RE: **Catalonia Subdivision**
Tr 1 & 2, The Trails Unit 3A
Drainage Report Stamp Date: 9/16/19
Grading Plan Stamp Date: 9/16/19
Hydrology File: C09D013

Based on the submittal received on 9/17/19 the above-referenced Drainage Report and Grading Plan cannot be approved until the following are corrected:

RE: Catalonia Subdivision
Tr 1 & 2, The Trails Unit 3A
Drainage Report Stamp Date: 7/11/19
Grading Plan Stamp Date: 7/11/19
Hydrology File: C09D013

DRAINAGE REPORT FOR CATALONIA AT THE TRAILS SUBDIVISION

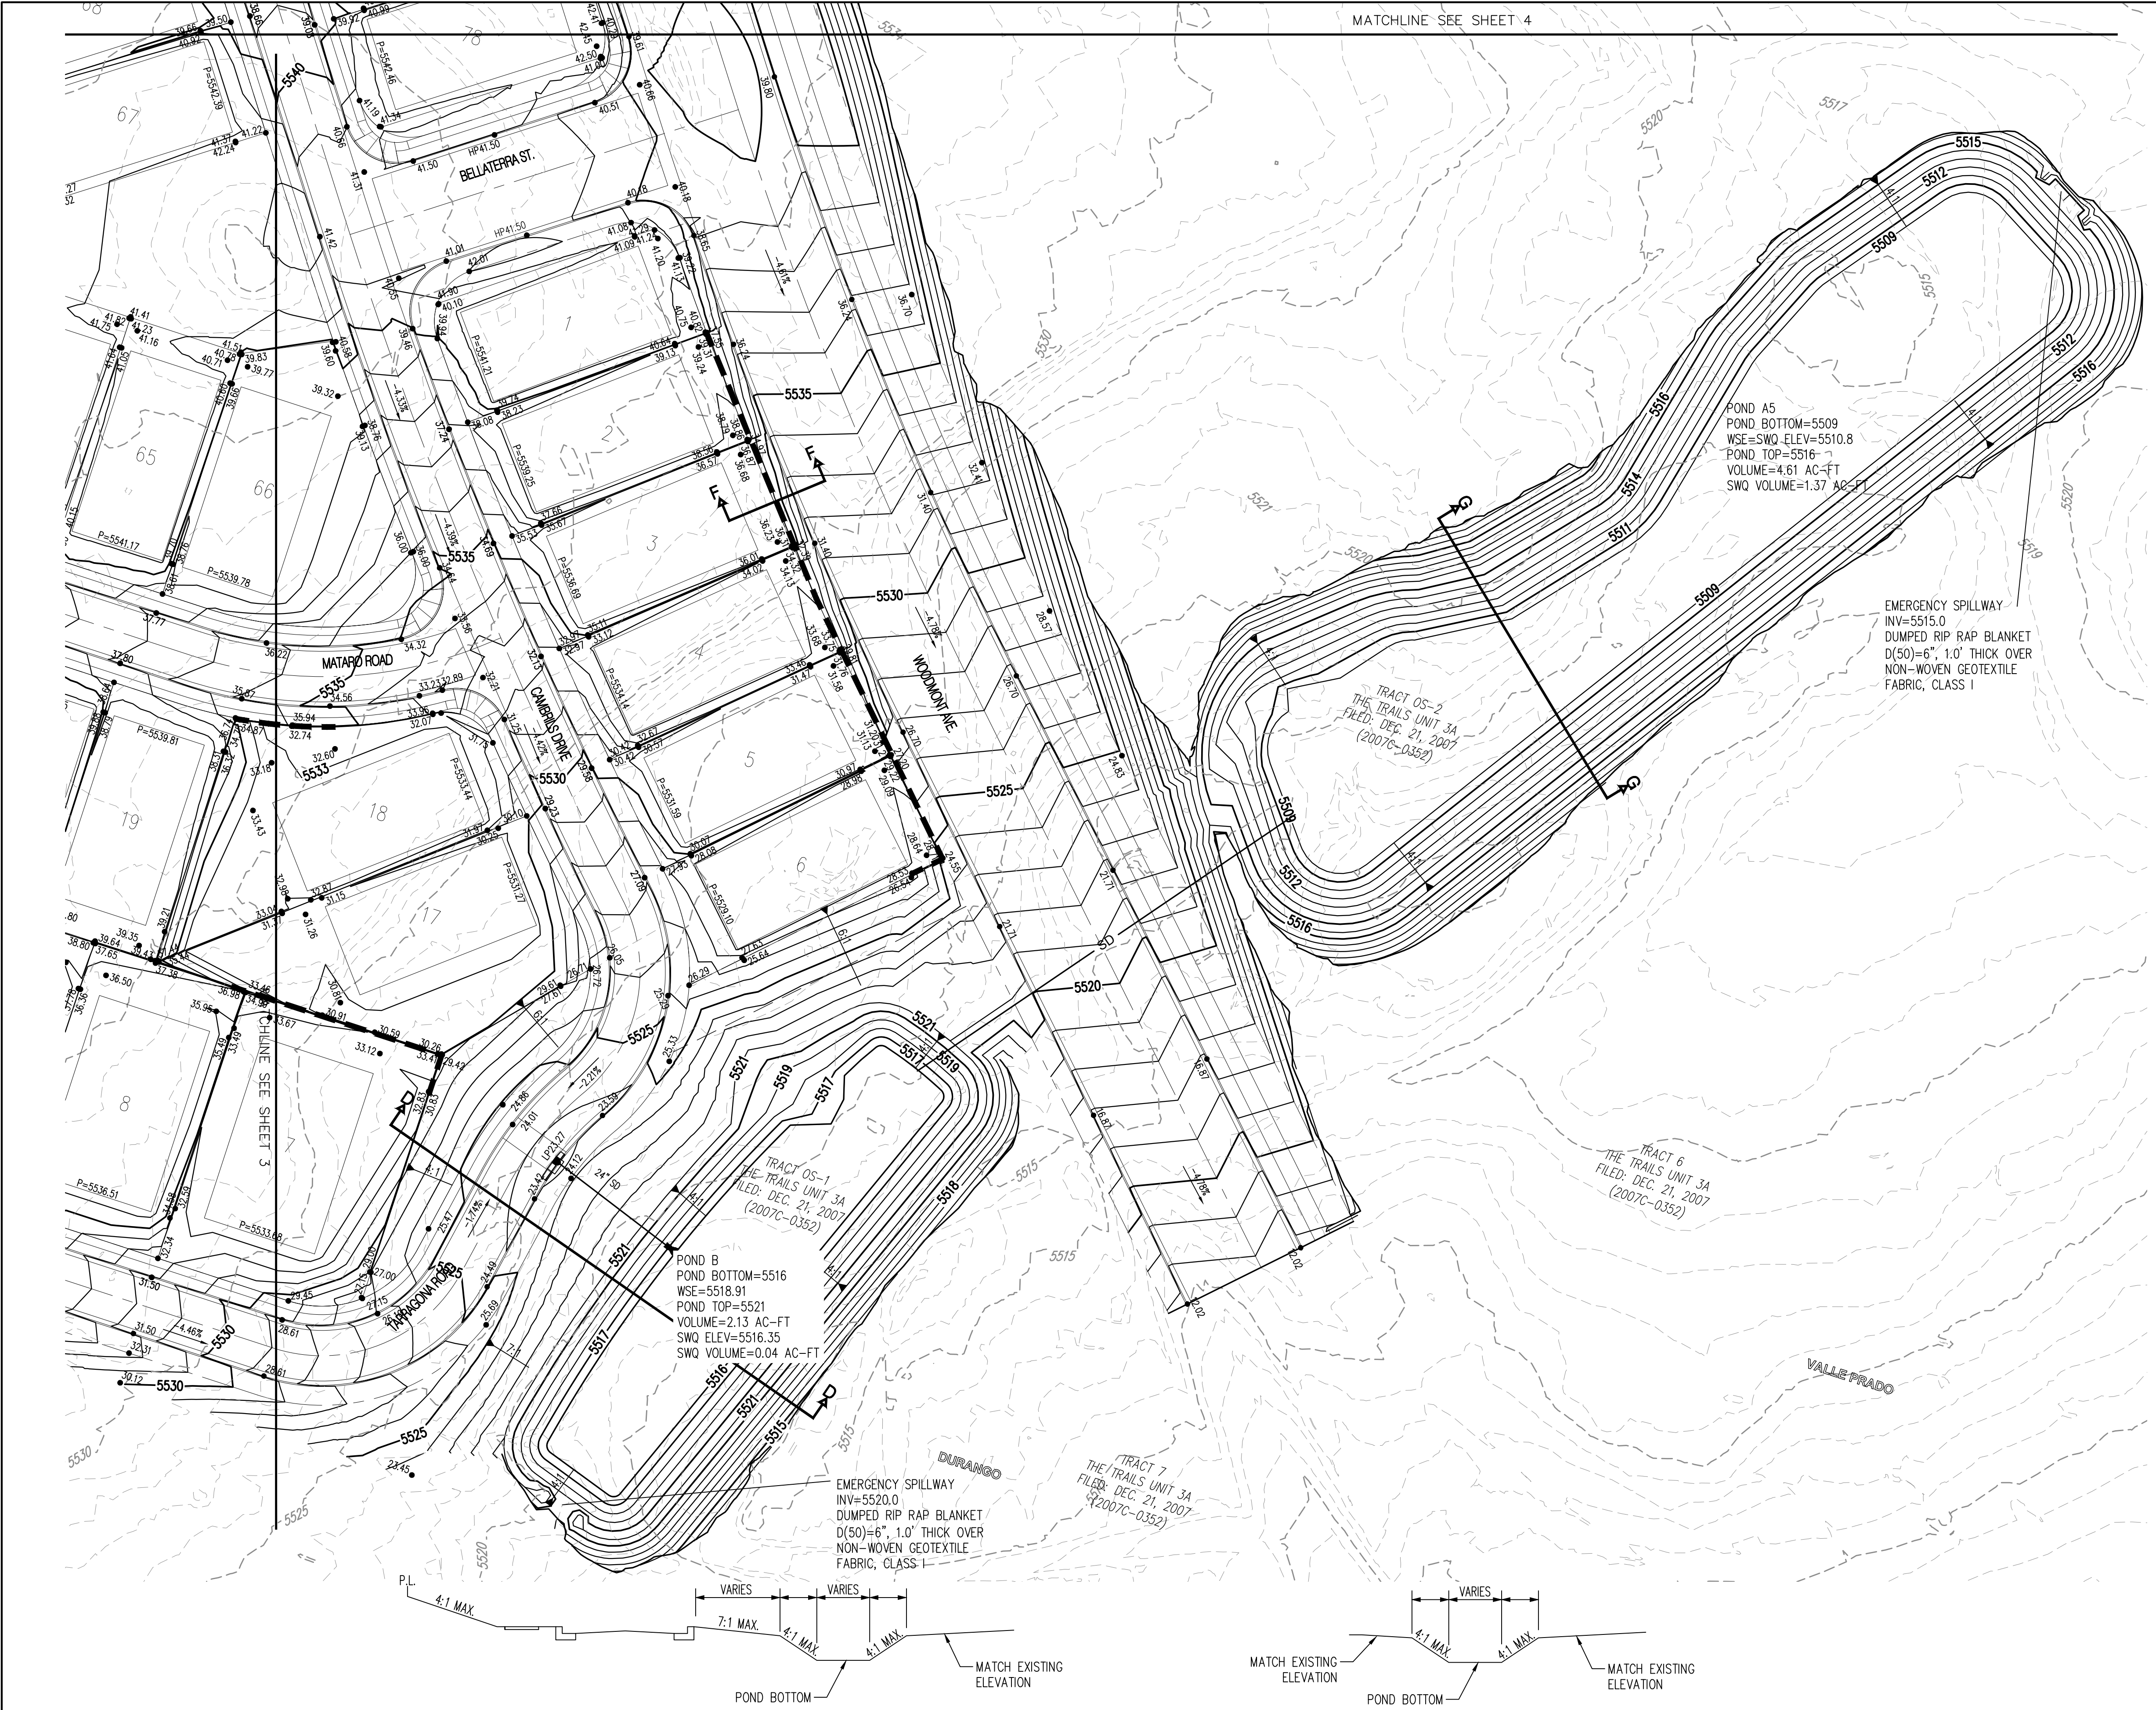
4. Please look at the Cambrils Dr assembly/section in front of lots 1-5. The contours seem to show an inverted crown with an odd transition in front of lot 6.
This has been updated.

EMERGENCY SPILLWAY
POND A5
NOT TO SCALE

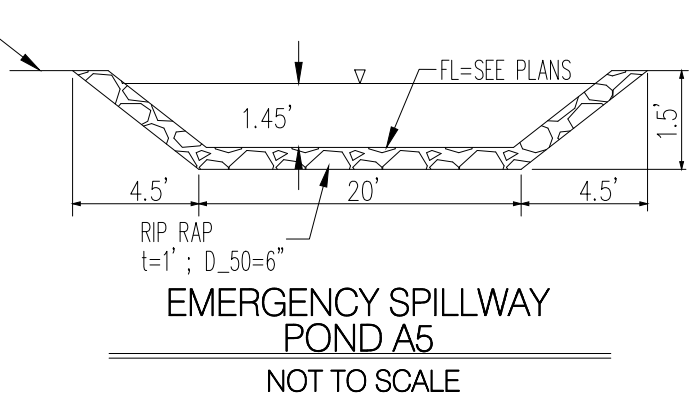
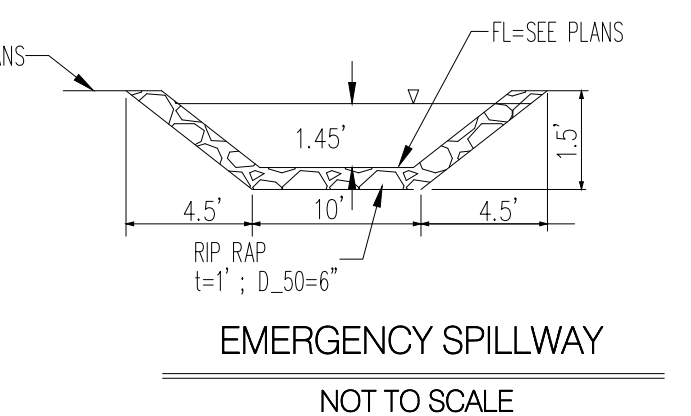
5. Provide dimensional data on plans (top width, bottom width, depth, etc.) for the spillways and swale.
6. Provide outlet structure detail for Offsite Pond 1 with 12" diameter orifice plate. Provide outlet structure detail for Pond B with 6" diameter orifice plate.

8. Provide dimensional data on plans (top width, bottom width, depth, etc.) for the spillways and swale.
This will be provided prior to Work Order.
9. Provide outlet structure detail for Offsite Pond 1 with 1' diameter orifice plate. Provide outlet structure detail for Pond B with orifice plate (diameter to be determined).
This will be provided prior to Work Order.
